ENGINEERING CHANGE PROPOSAL

ECP NUMBER SJ-M/O-4655	TITLE Sugarland Terminal LoCap to B.C. Meter Connection
BUDGET SOURCE	AUTHORITY ☒ PCCB ☐ ECC

NUMBER: SJ-M|O-4655
TITLE: **Sugarland Terminal LoCap to B.C. Meter Connection**

DWG NAME: 30"-0001-A

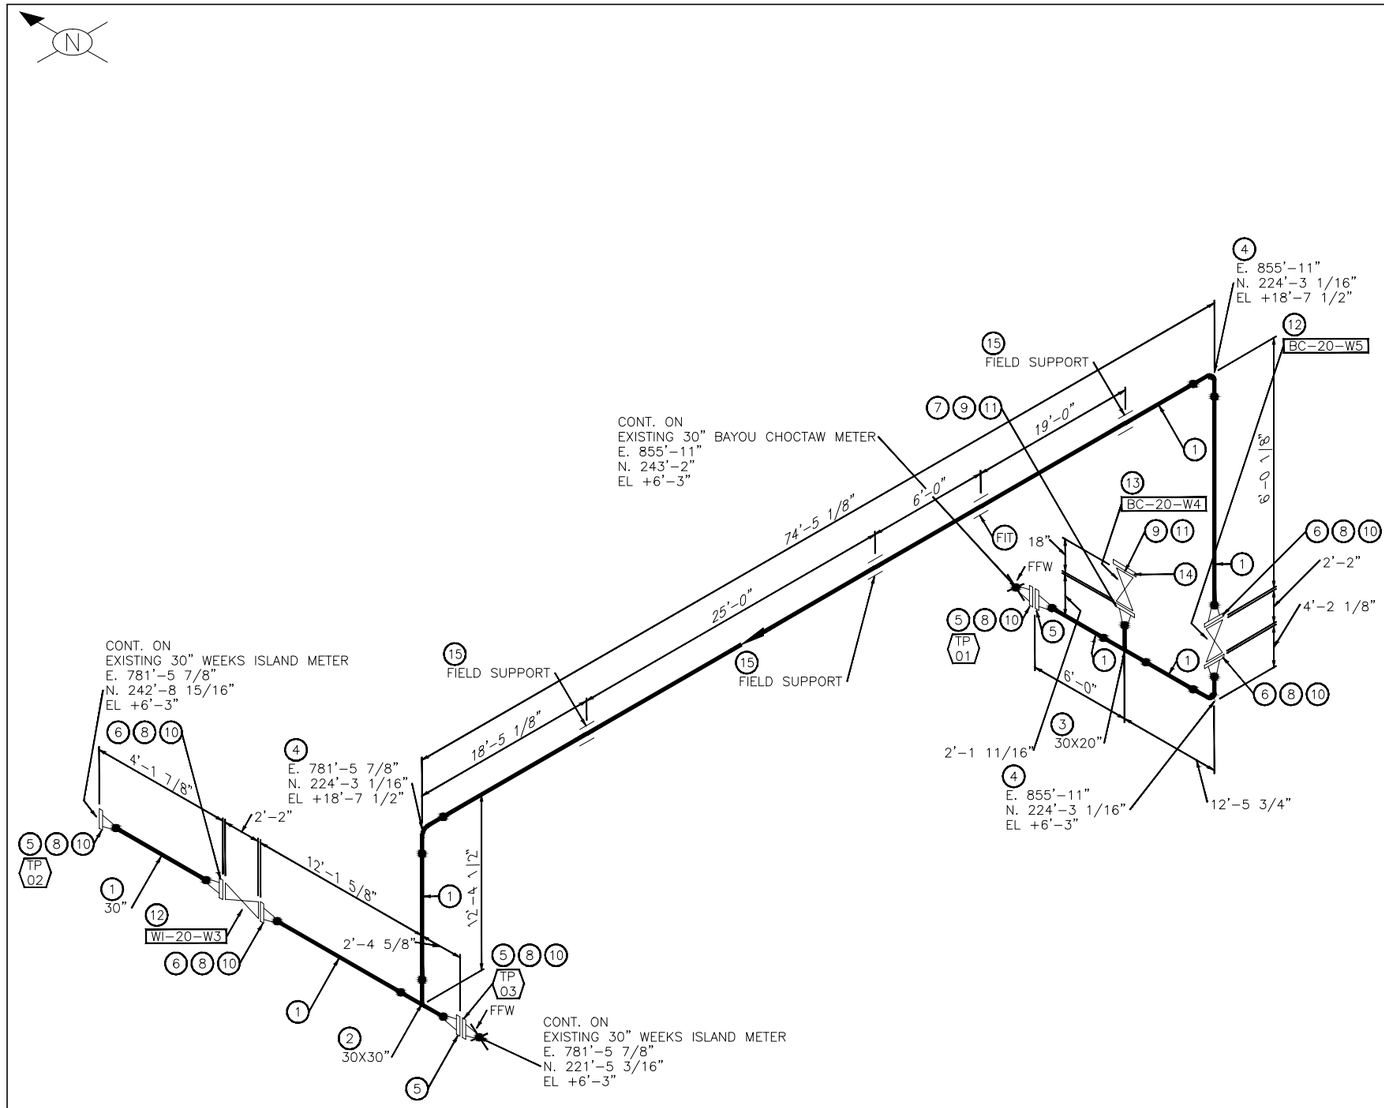
- Installation of 110 feet of pipe plus fittings from the other branch of the tee to the downstream of the WI meter which goes to the LoCap line. Hydrostatic testing will be completed on the line upon installation.

PLOT PLAN
METER MODIFICATIONS
SUGARLAND FACILITY
ST. JAMES, LOUISIANA

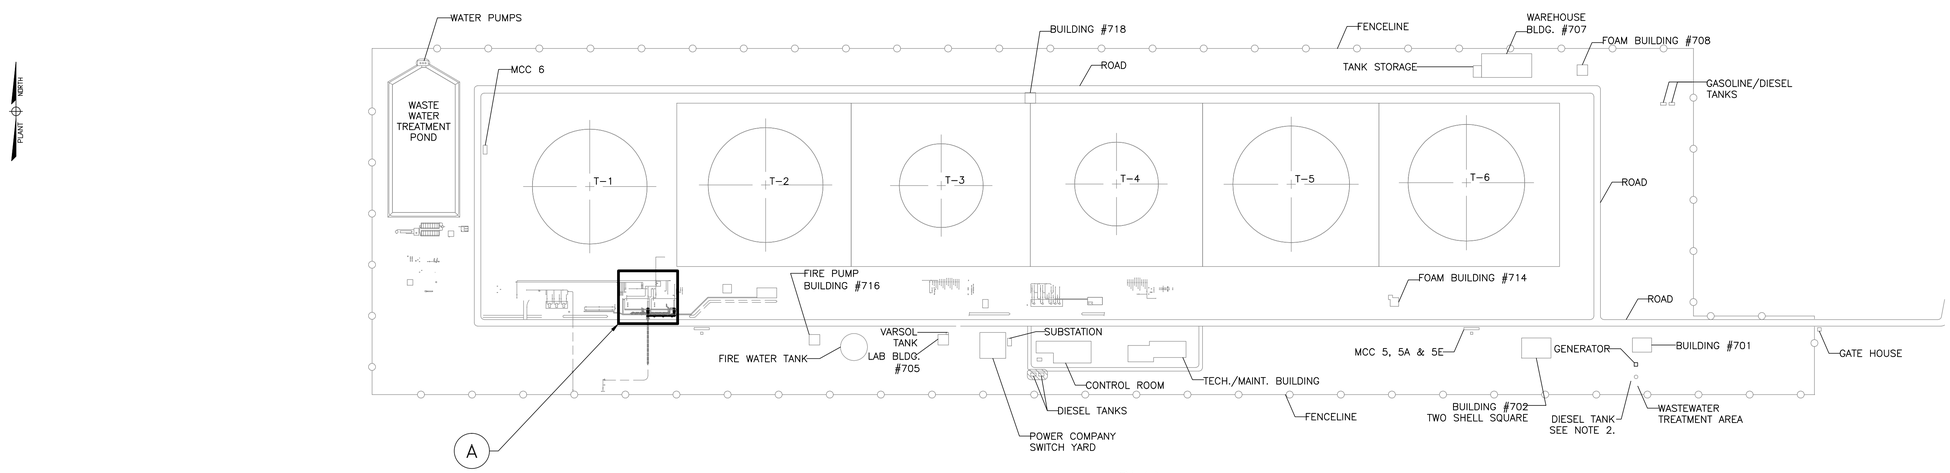
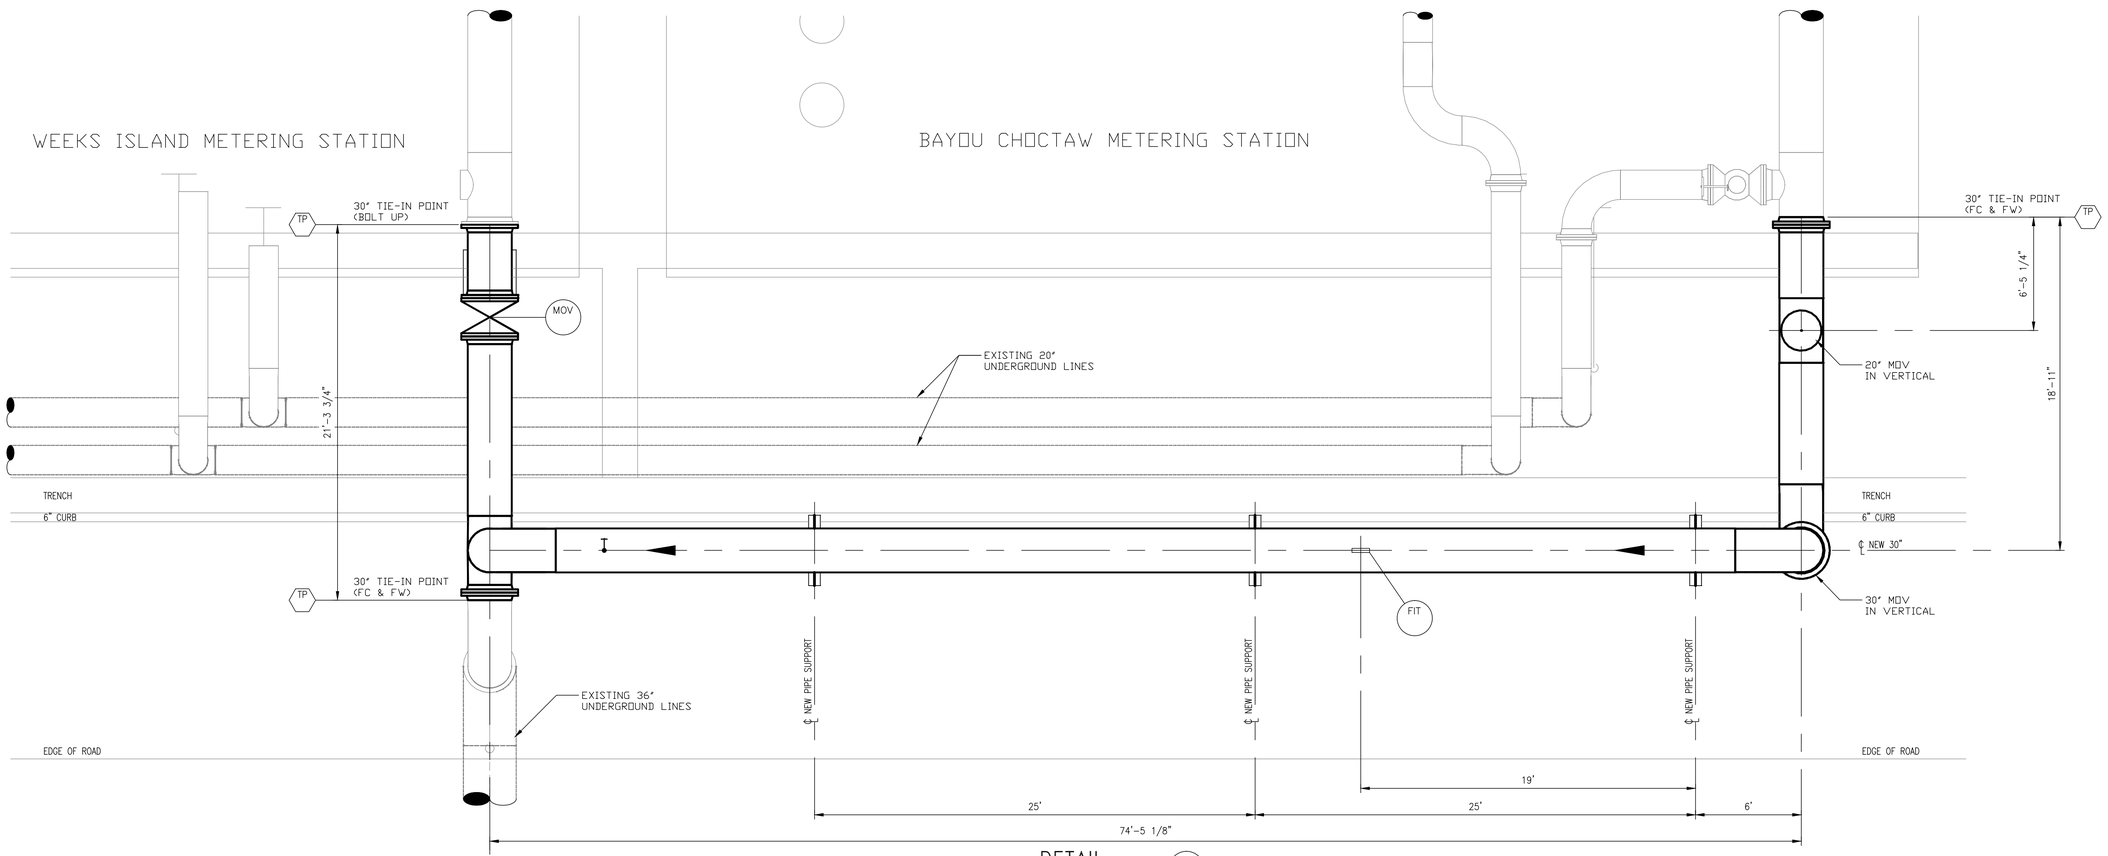
A connection from the Bayou Choctaw Meter to the Weeks Island Meter outlet to LoCap would allow simultaneous barge loading and LoCap movements as well as an increased flow rate to LoCap due to the higher capacity of the Bayou Choctaw Meters.

- Installation of one DBB valve on BC meter side and one DBB valve at the WI tie-in side.
- Installation of up to three required pipe supports. Pipe support will be up to 20' deep w/ 30" dia drilled shaft foundation till 12" above ground, then steel wide flange column with steel wide flange beam on top of the column below the pipe (T support).

VALVE CHART
DOE – SUGARLAND TERMINAL

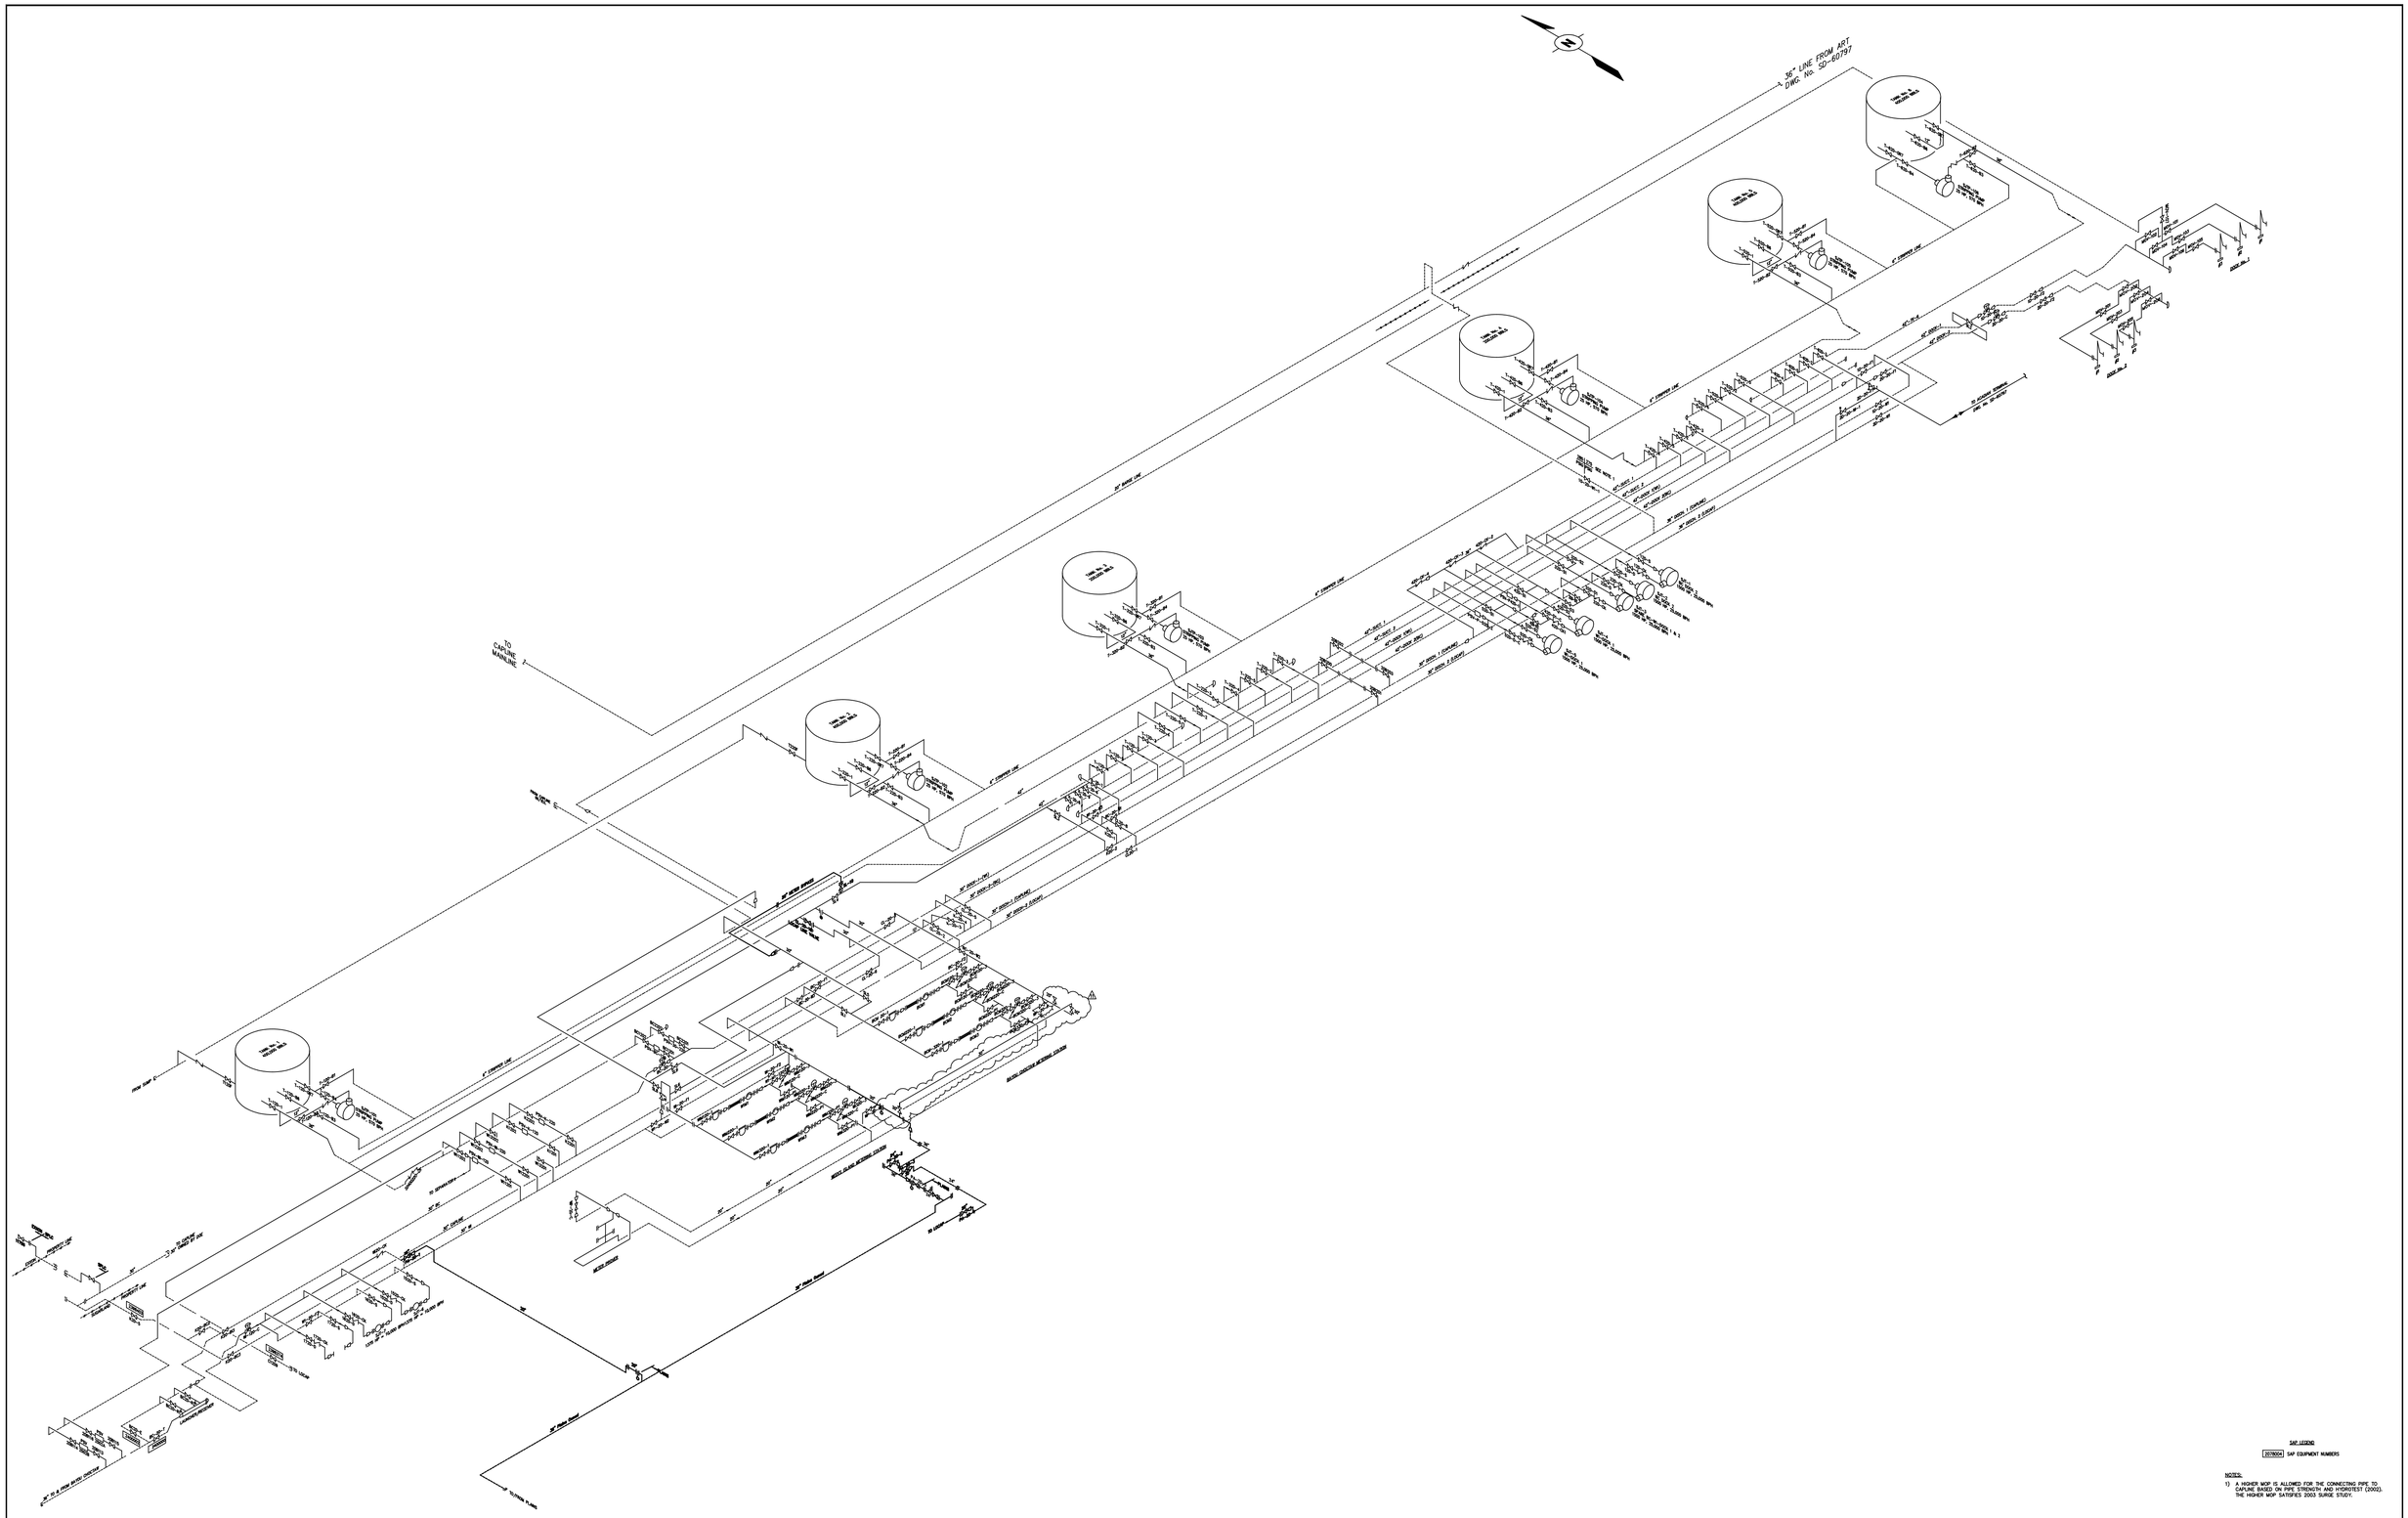
CAD DRAWING DO NOT REVISE MANUALLY	10	01/08	ADDED PLAINS 3-VALVE MANIFOLD AND LOCAP AND REDISTICK CONNECTIONS	BDE	SJA	SJA	KNM
	09	10/06	ADDED SL-10 W/ MTR BYPASS, CL-20-10 (05190) & MODIFIED W/ METER OUTLET	BDE	SJA	SJA	SJA
	08	04/05	ADDED SAP EQUIPMENT NUMBERS	BDE	DPB	DPB	LJW
	07	04/05	REMOVED PSV-W1-320 REVISED XOVER ON SUC.1 & 2 LINES	BDE	JEH	JEH	JEH
	11	11/12	BAYOU CHOCTAW AND WEEKS ISLAND BYPASS LINE	SKW	LG	SK	
	REV	DATE	DESCRIPTION OF REVISION	BY	CHK	DES	APP
